## J2 TECHNICAL ARTICLE

December 17, 1981

Resource: M.G. Car Company Ltd.  
Issued June 1933

### INFORMATION SHEET NO. 5 -- GEAR LEVER RATTLE

It has been found that a spring fitted as shown in the drawing (Service Blue Print No. 146) prevents rattle most effectively.

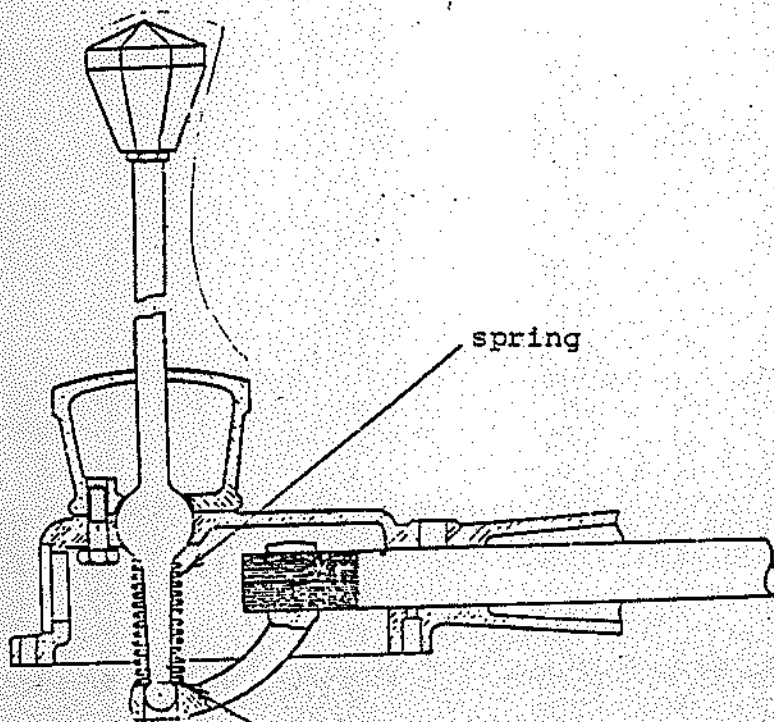
Complaints of rattle in the gear change remote controls have been made from time to time, and up till recent no very satisfactory cure has existed.

spring must sit on actuating lever.

The Part Number of the spring in question is 2747, and this number, together with the chassis Number of the car concerned, must be quoted when ordering for service.
